**ADDENDUM 3 TO BID DOCUMENTS FOR THE  
CAMERON MEADOWS MARSH CREATION AND TERRACING  
PROJECT  
(CS-0066)**

**CAMERON PARISH, LOUISIANA**

**STATE OF LOUISIANA  
COASTAL PROTECTION AND RESTORATION AUTHORITY**

**April 13, 2020**

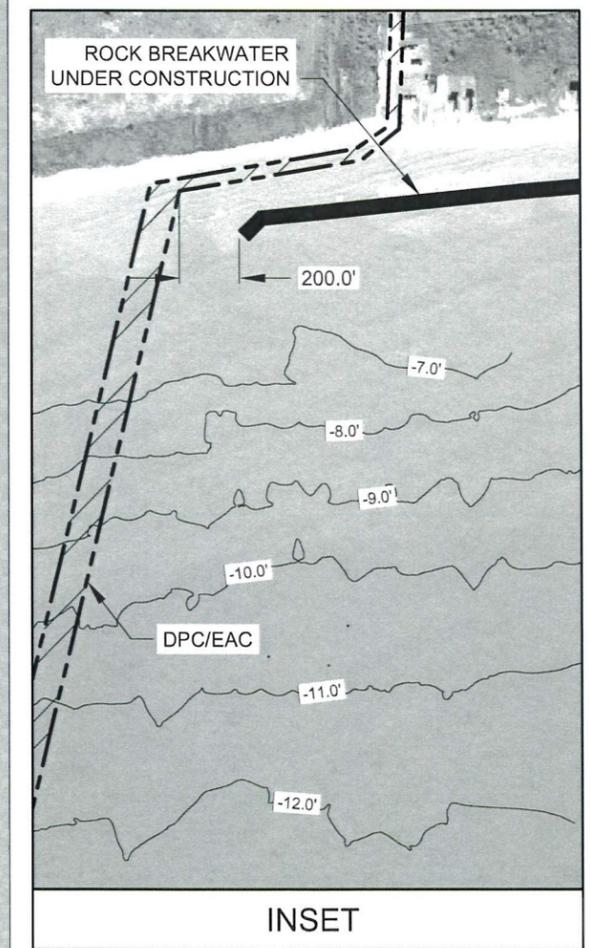
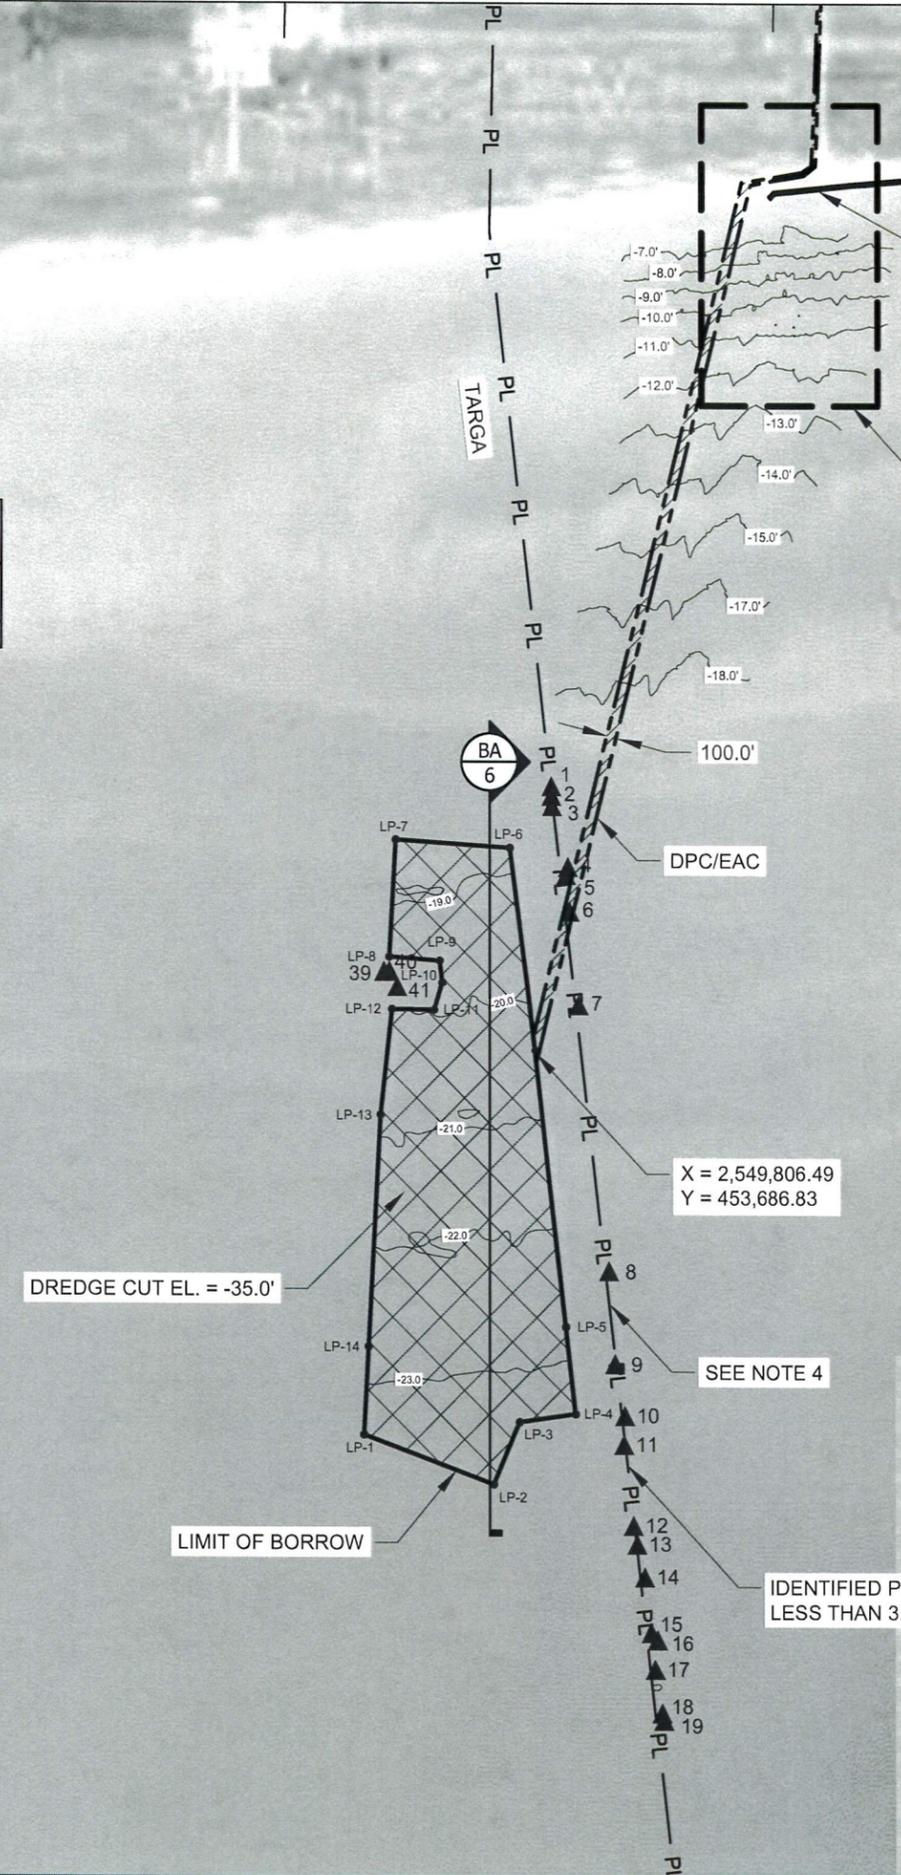
6. **Question:** Can you please verify the coordinates of the offshore borrow area in particular points 5-14, when they are plotted in AutoCAD they are not in the same position as what is shown on the plans on page 5.

Plan Sheet 5: Corrects coordinates for the Marsh Creation Borrow Area. Adds Cameron Parish Shoreline Protection Project at Long Beach, which is anticipated to be complete by December 2020. Updates Equipment Access and Dredge Pipeline Corridor Route. Removes Stone Energy pipelines and associated magnetic anomalies.

**CPRA Response 6:** Plan Sheet 5 has been revised. See Section IV of this Addendum for revisions to Plans and Specifications.

REV.	DATE	DESCRIPTION
A	3/23/20	UPDATED LIMIT OF BORROW
B	3/27/20	AREA COORDINATE TABLE ADDED CAMERON PARISH SHORELINE PROTECTION FOOTPRINT TO SHEET

CONSTRUCTION SURVEY LAYOUT  
 DESIGNED BY: TYE FITZGERALD, P.E. - 0038153  
 APPROVED BY: RUDY SIMONEAUX, P.E.

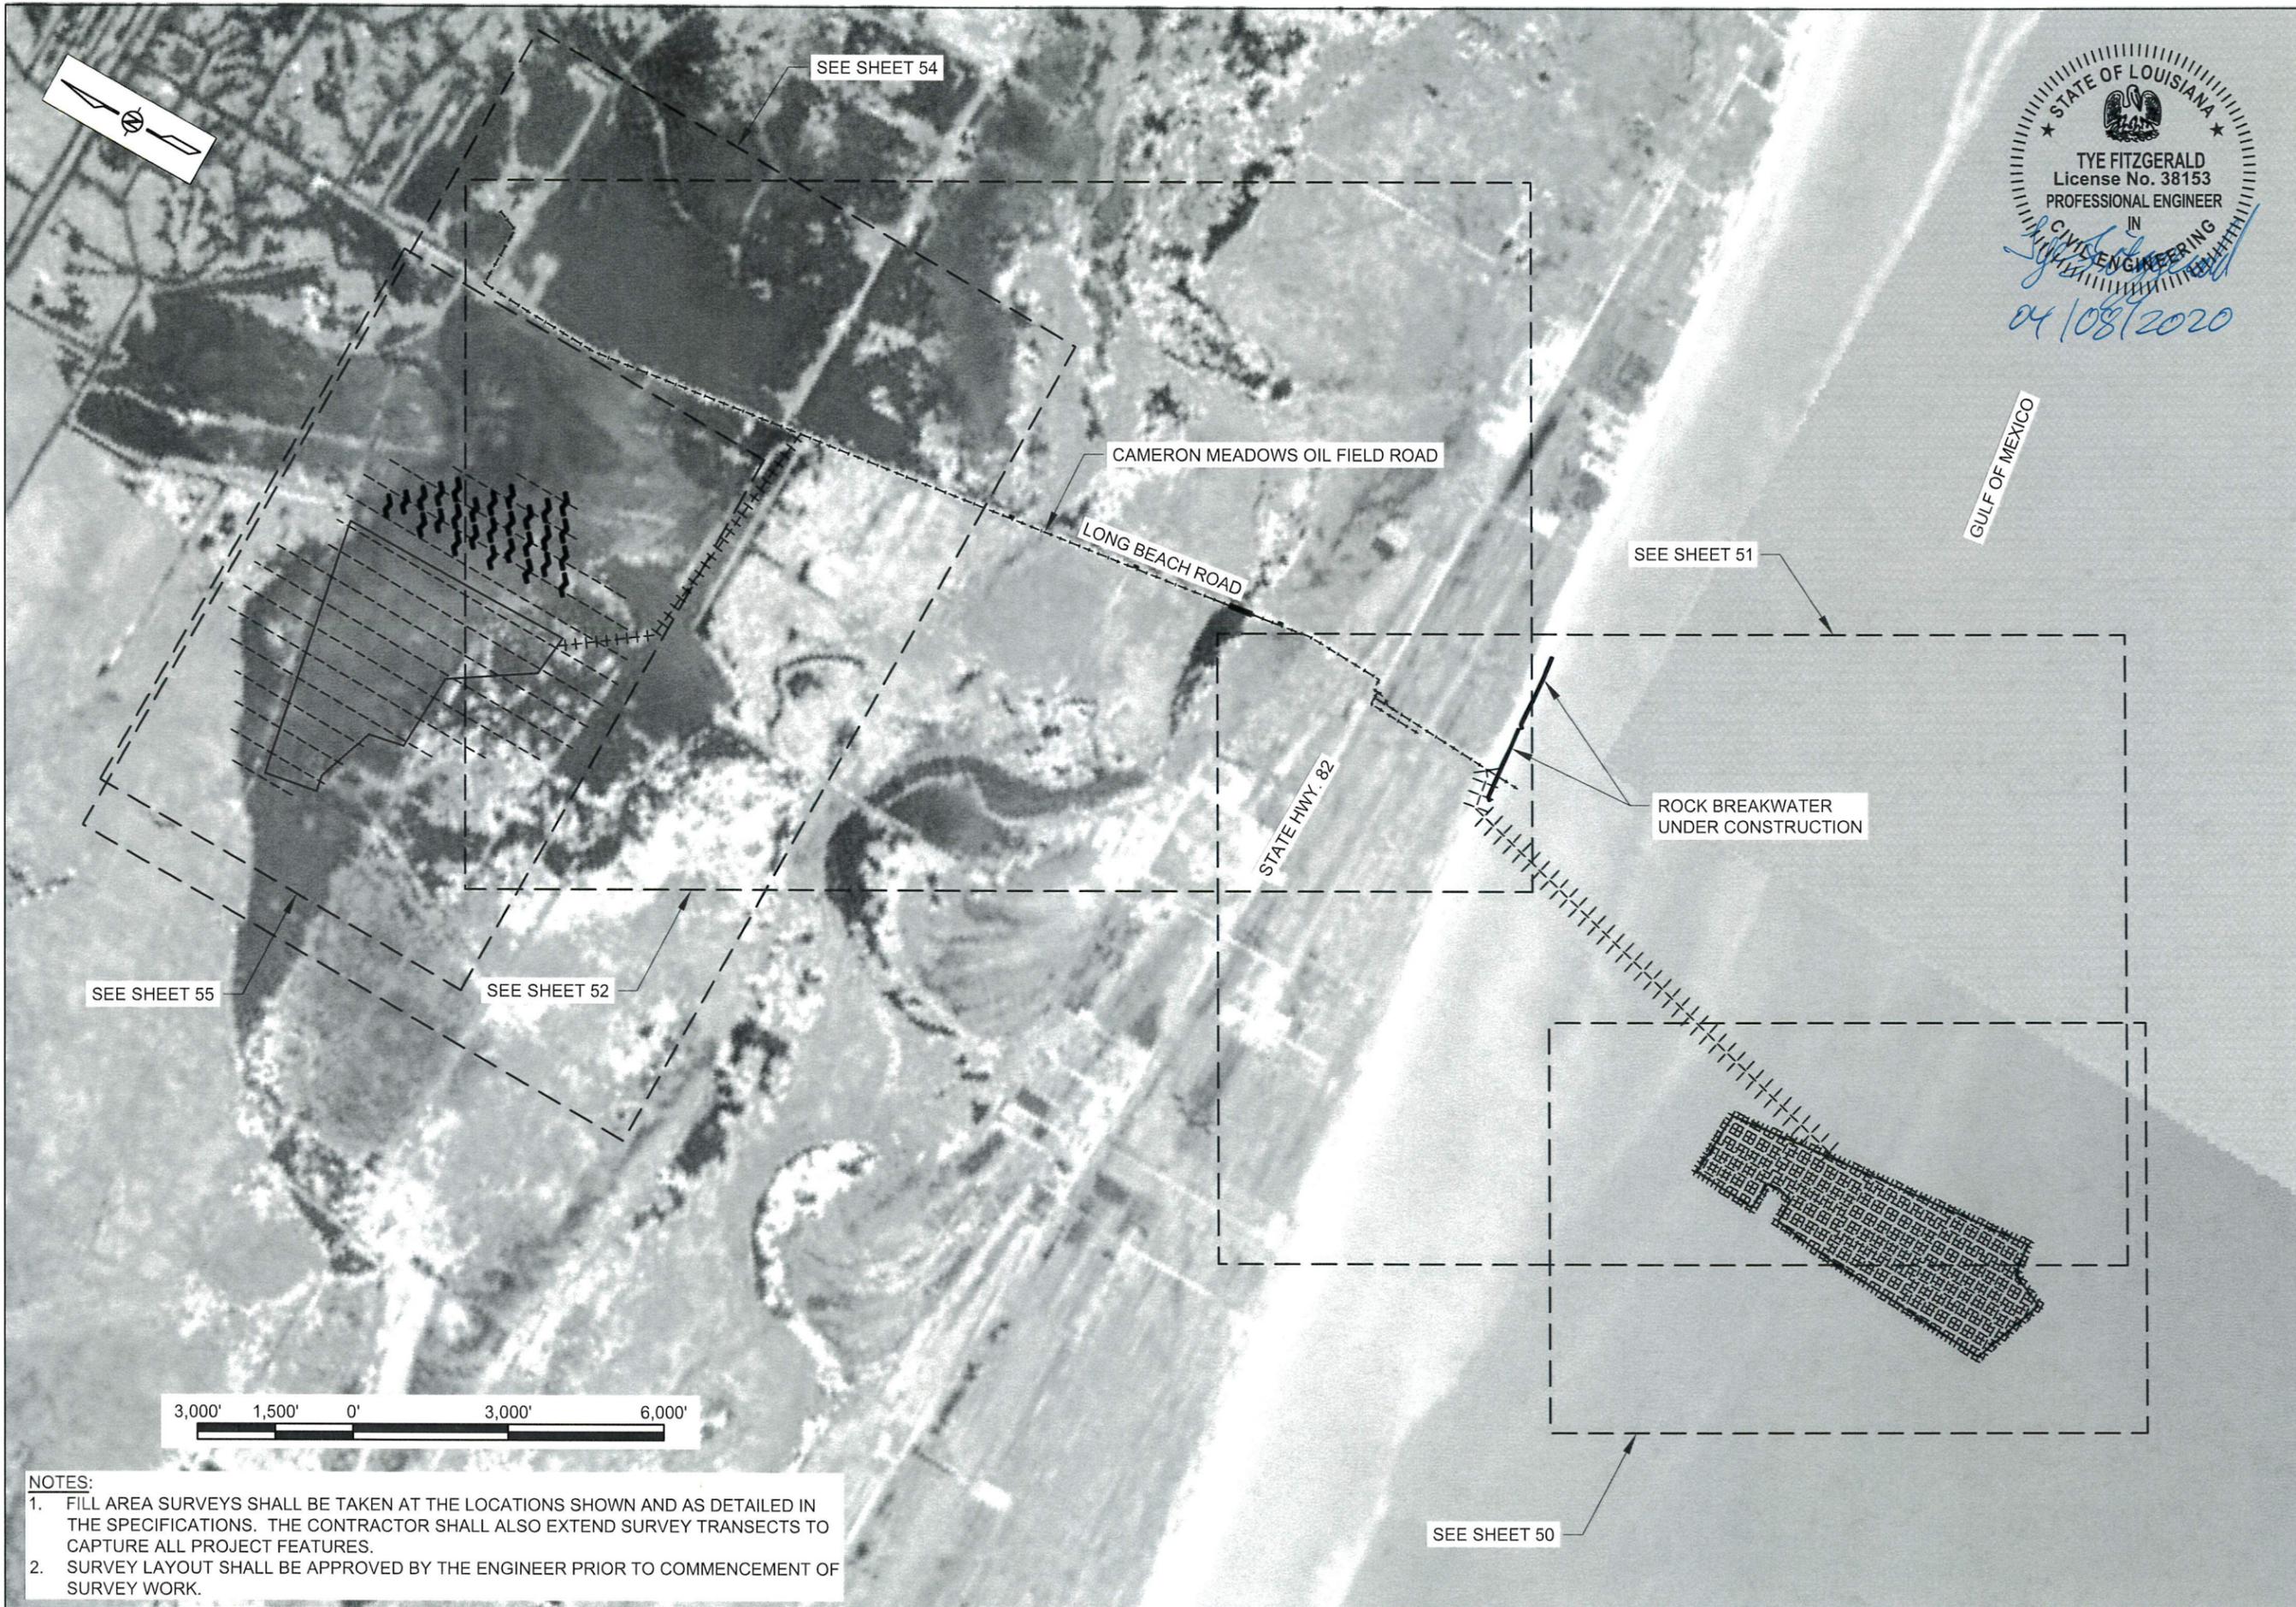
Plan Sheet 49: Adds Cameron Parish Shoreline Protection Project at Long Beach, which is anticipated to be complete by December 2020. Updates Equipment Access and Dredge Pipeline Corridor Route construction survey layout. Adds survey layout for Phillips Oilfield Road.

ADDED CAMERON PARISH	3/27/20	REV.	DATE	DESCRIPTION	BY
SHORELINE PROTECTION					
FOOTPRINT TO SHEET					SF

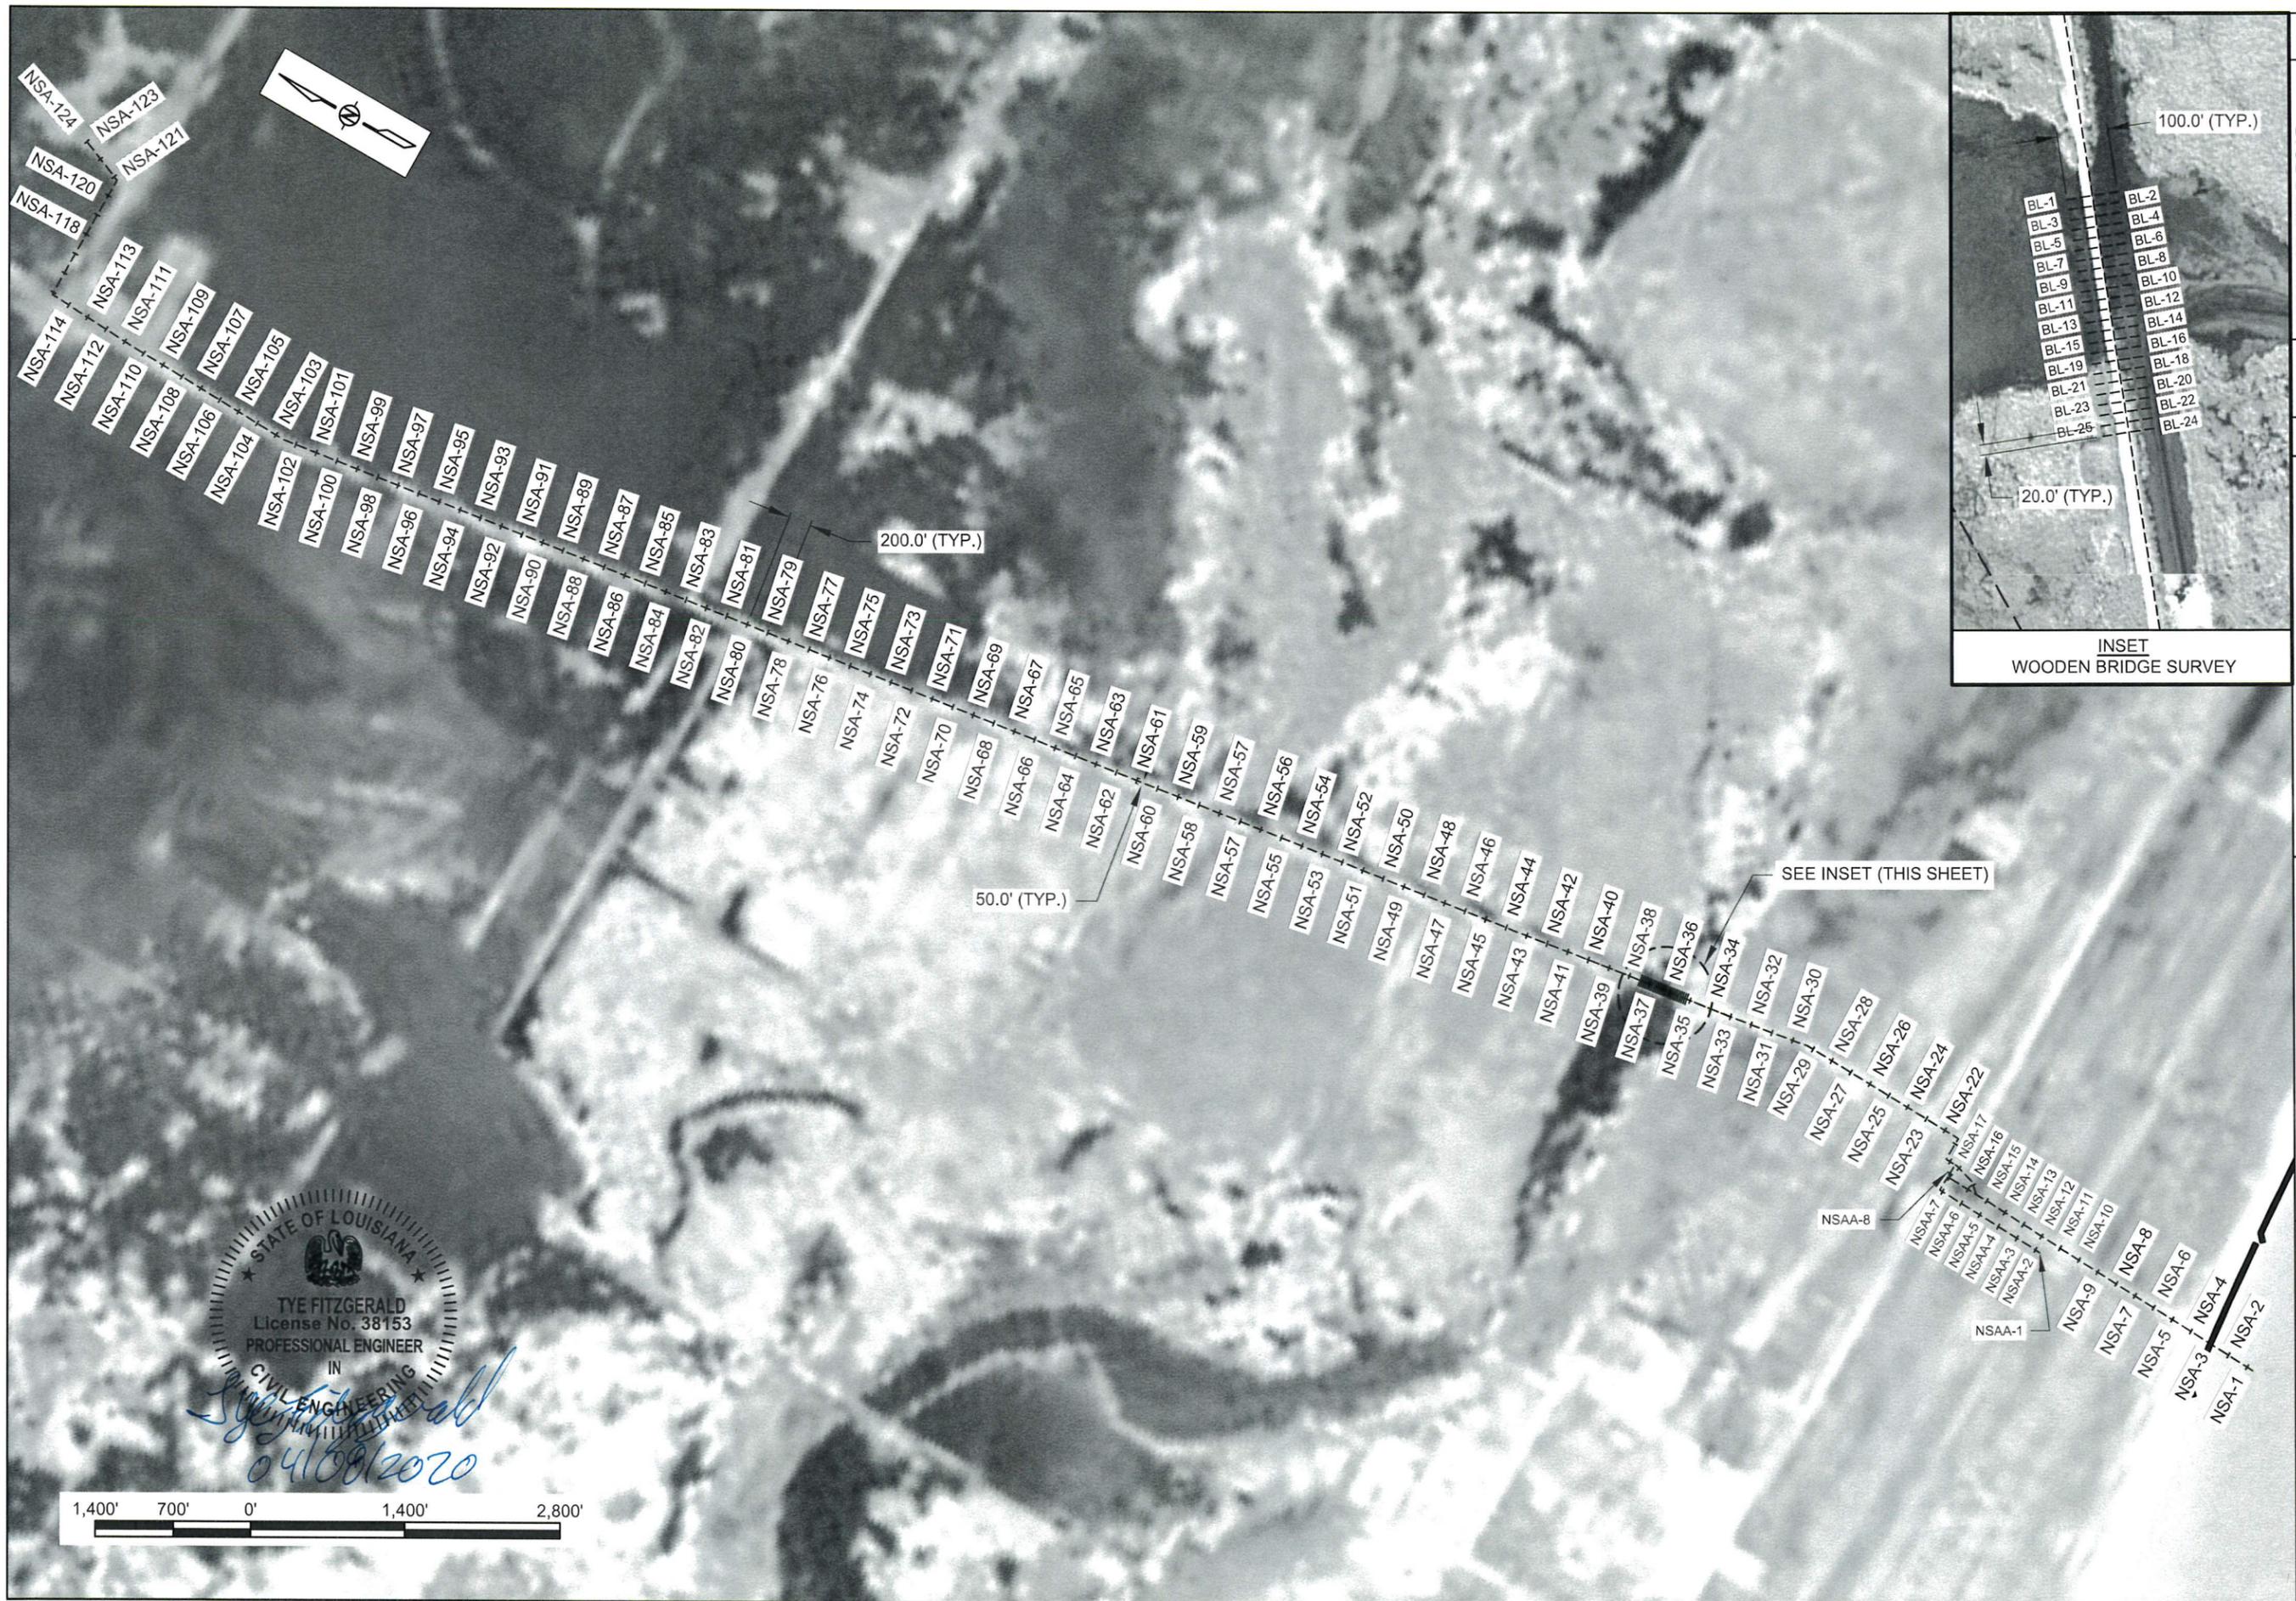
Plan Sheet 51: Adds Cameron Parish Shoreline Protection Project at Long Beach, which is anticipated to be complete by December 2020. Updates Equipment Access and Dredge Pipeline Corridor Route construction survey layout.

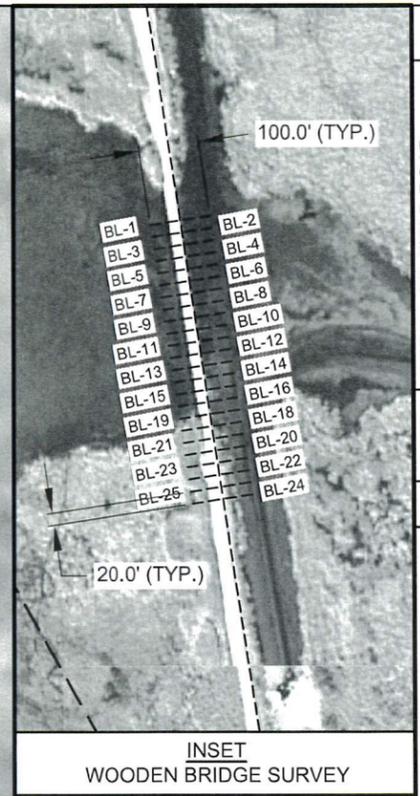
9. **Question:** Are there any surveys required on the Phillips Oil Field Road Equipment Access Corridor?

Plan Sheet 52: Adds Cameron Parish Shoreline Protection Project at Long Beach, which is anticipated to be complete by December 2020. Adds survey layout for Phillips Oilfield Road.

**CPRA Response 9:** Yes. See revised Plan Sheets 49 and 52 and revised TS-200.7.6.7 included in Section IV of this Addendum.
